MEMORANDUM

From:	Catherine Brimble Senior Landscape Officer		
Service	SDL Landscape and Trees	App No:	251263
Address:	Parcel 6, Finchwood Park, Sheerlands Road, Arborfield, Wokingham, RG40 4QY.		
Proposal:	Application for approval of Reserved Matters pursuant to Outline Planning Consent O/2014/2179 (as varied by 181194, dated 14/11/2018). The Reserved Matters comprise details of 140 dwellings, together with associated internal access roads, parking, landscaping, footpath and sustainable urban drainage systems (SuDS). Details of access, appearance, landscaping, layout and scale to be considered.		
Type of Development:	Major Dwellings (10+)		
Site Visit Made:	Yes/No

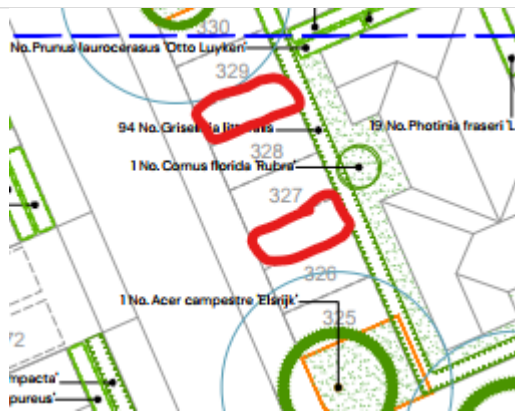
- e) There are a number of locations where a small area of native shrub mix is proposed between the edge of the private drive and the swale. Two examples are shown below. I consider that this type of planting is not appropriate in this area and suggest that in all locations such as this, the native shrub planting is replaced with prairie style planting with an emphasis on the use of ornamental grasses and perennials. It will provide a transition between the development edge and the more informal open space. **The native shrub mix has been removed; however, this has been replacing with grass rather than the suggested prairie style planting to provide a transition as indicated above. I would like to see this included but can be addressed through a conditions application.**
